TG13.1 – Roof Park Landscaping and Irrigation

Questions are numbered in the order received. Numbers missing in the sequence either have been answered in a previous response set or will be answered in a future set.

Response to RFI TG13.1-013 & 014

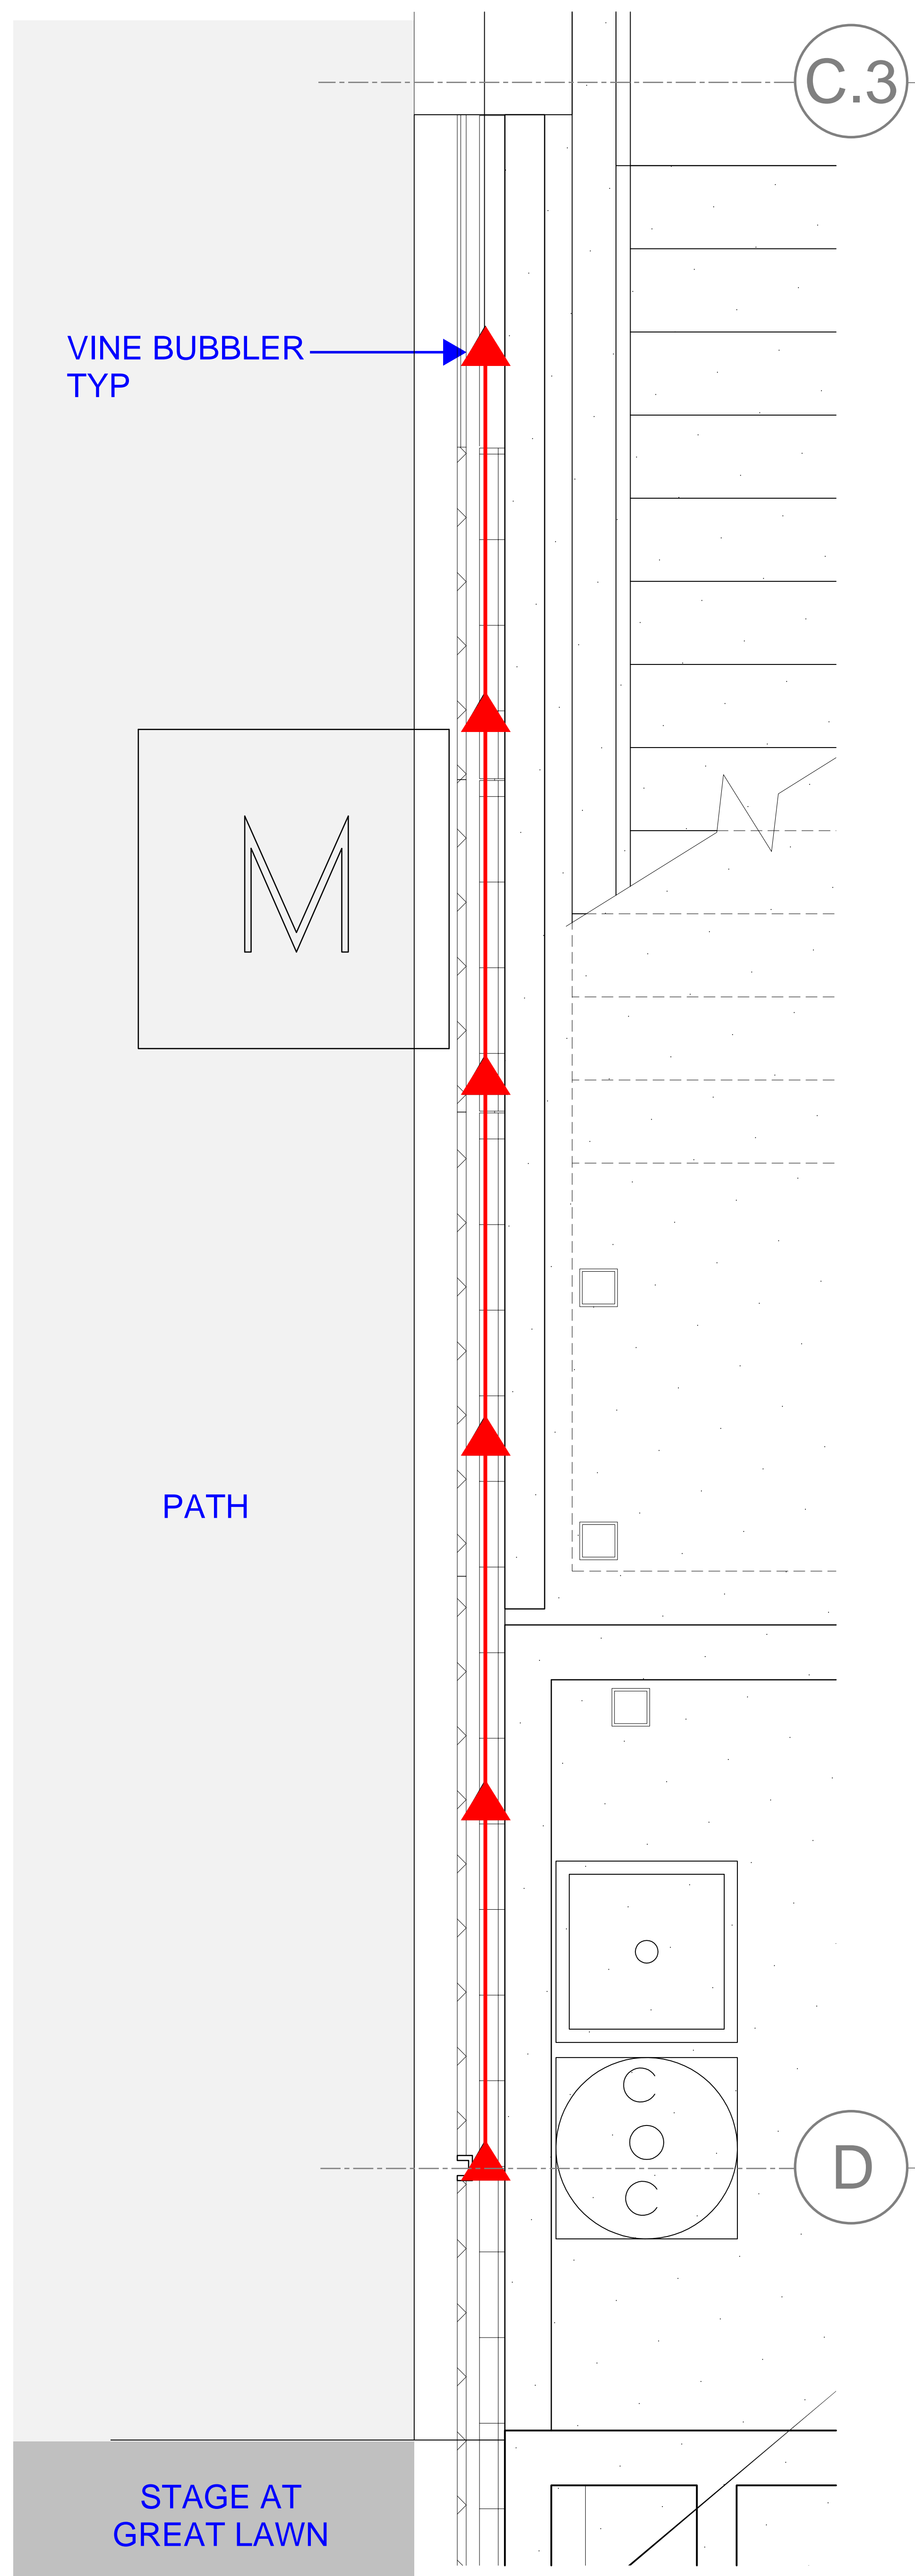
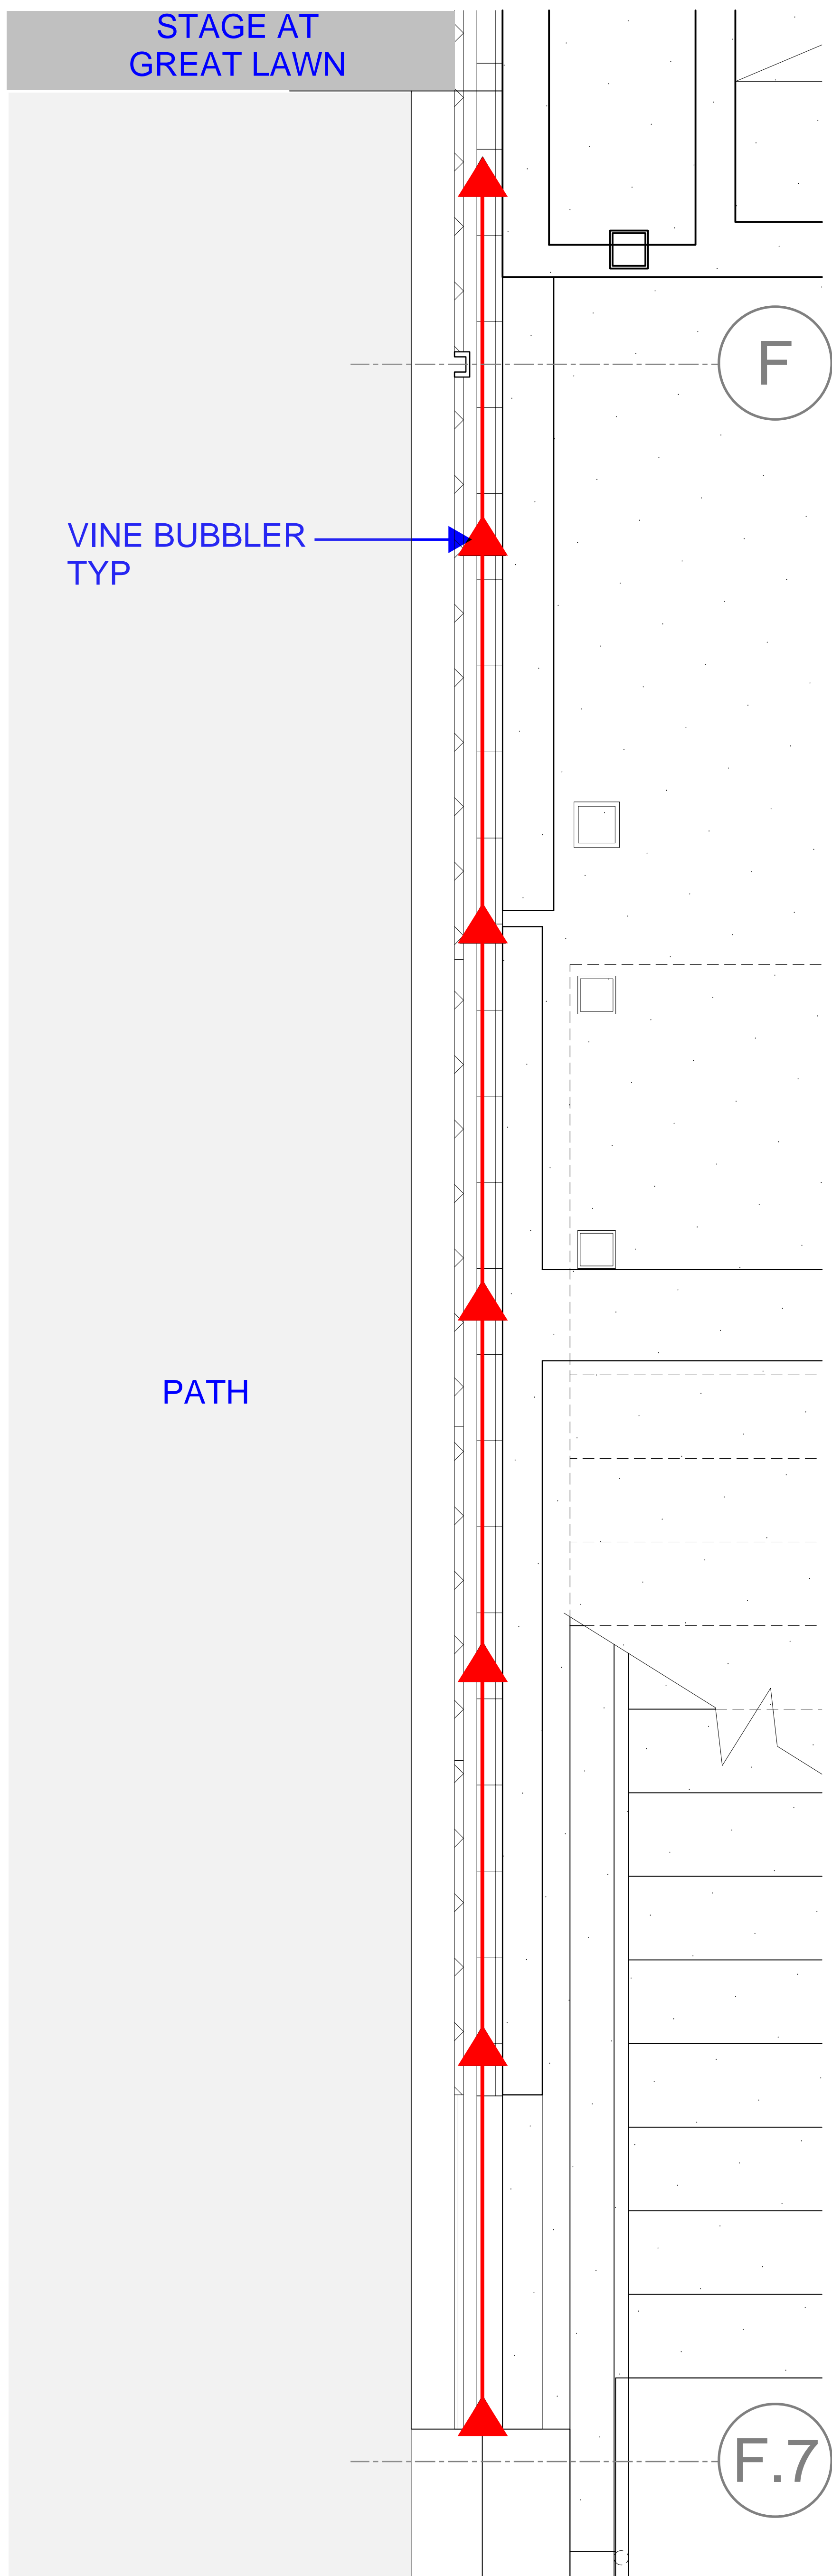
TG13.1-013	3/25/2015	L1-6632		Vine plantings are indicated on GL 4, but there are no vine bubblers. Confirm that there should be vine bubblers on GL 4 and provide updated details.	Vine bubblers on GL 4 have been shown on sheet L1-6632. Please refer to the attached SKLA 388.1 and 388.2 to see vine bubbler locations.
TG13.1-014	3/25/2015	L1-6632		Confirm that the Subsurface Drip Irrigation indicated as a broken line on L1-6632 is meant to be solid and is the same as the Subsurface Drip Irrigation indicated with a solid line on L1-6633 thru L1-6637.	Confirmed. The subsurface drip irrigation on L1-6632 is solid-line type. Please refer to SKLA 388.1 attached to Q&A TG13.1-013.
TG13.1-016	3/25/2015	E1-2602, L1-1602		There is a conflict between the Utility Corridor Routing on E1-2602 and L1-1602. Which routing is correct and should be priced?	Please refer to the attached SKLA 379-1 REV, 379-2 REV, 379-3 REV, 379-4 REV, 379-5 REV, and 379-6 REV for utility corridor routing.

VINE BUBBLERS AT NORTH VINE PLANTING AREA

VINE BUBBLERS AT SOUTH VINE PLANTING AREA

DRAWING TITLE: **Response to RFI**
TG13.1-018

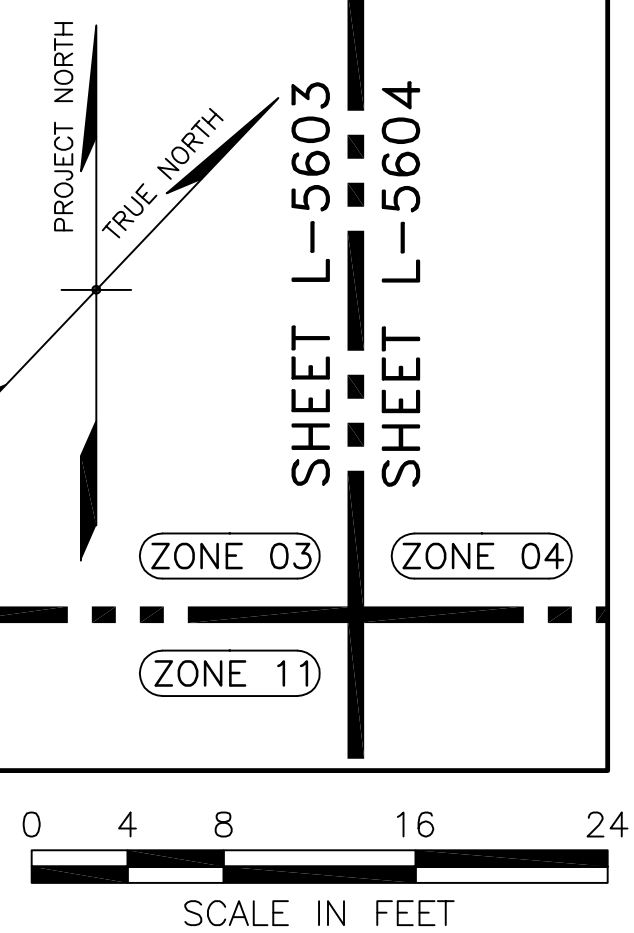
TG13.1-017	3/25/2015	E1-2602, L1-1602		Confirm that the intent of the Utility Corridor Routing is meant to run through the CMU foundation of the Amphitheater Stairs.	Confirmed. Refer to sketches attached to Q&A TG13.1-016.
TG13.1-018	3/25/2015	A1-2903, L1-5603, P1-2603, A1-2913, L1-2623, L1-4603		At GL 6.3 / D there are roof drains indicated on A1-2903, L1-5603, P1-2603, but not on A1-2913, L1-2623, L1-4603. Clarify if there are roof drains at GL 6.3 / D and if a Precast Concrete Roof Drain Enclosure is required for this location. Confirm that the Precast Concrete Roof Drain Enclosure will not conflict with the Restaurant.	A precast concrete roof drain enclosure is not required at the location indicated in the QBD. Roof drains at grid lines 6.3 / D have been removed. Please refer to the attached sketches: SKLA-386, SKP1-2503, SKP1-2603 and SKP1-5010.

1. REFER TO IRRIGATION, ELECTRICAL AND PIPING PLANS TO COORDINATE UTILITY TRENCH CONSTRUCTION WITH GEOSYNTHETIC FILL INSTALLATION.
2. REFER TO SOILS AND GRADING PLANS AND DETAILS FOR PROPOSED SOIL DEPTHS AND TRANSITION DETAILS
3. FOR FINISHED SURFACE ELEVATIONS OF PROTECTION SLAB REFER TO ARCHITECTS DRAWINGS.
4. REFER TO PLANTING DETAILS FOR PLANT PIT CONSTRUCTION.
5. REFER TO GRADING PLAN FOR FINISHED SURFACE ELEVATIONS.
6. PROVIDE SHOP DRAWING FOR REVIEW AND APPROVAL.

D. ANGHEL
W. GAW
W. GAW
G. CRAIG
J. WHITNEY
12/16/2014
1/8" = 1'-0"
RFI TG13.1-019

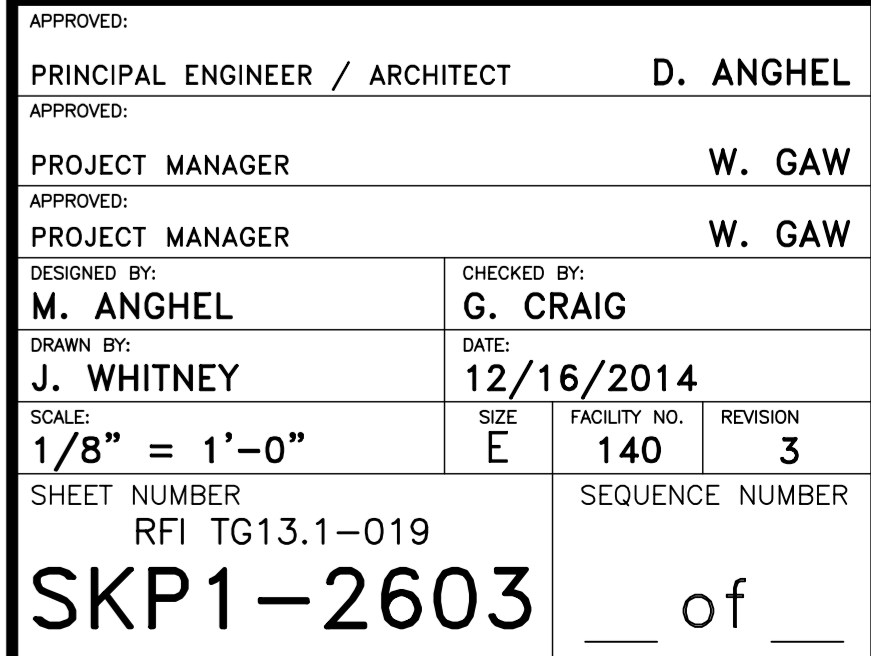
TG13.1-019	3/25/2015	A1-2913, P1-2603, L1-3603, L1-4603		At GL 7.8 A1-2913 shows four openings in the protection slab with the slab sloping towards these openings which appear to be drains. P1-2603 shows four ghosted squares, but no roof drains in that location. L1-3603 and L1-4603 show two surface drains, with finish grade sloping toward the two drains and the effluent routing to the roof drains on GL 8.5. Confirm that there are two drains as shown on L1-3603 and L1-4603 and not four as indicated on A1-2913. Provide updated coordinated sheets showing either two or four drains.	Please refer to updated drain penetrations per attached sketches SKP1-2503, SKP1-2603, SKA-4575 and SKA-4579. Landscape drawings are correct as shown, indicating only the two surface drains. For slab penetrations, refer to Architectural and Plumbing drawings. Four drains at the main slab are correct as shown on the protection slab drawings. Surface area drains will not be shown on plumbing drawings.
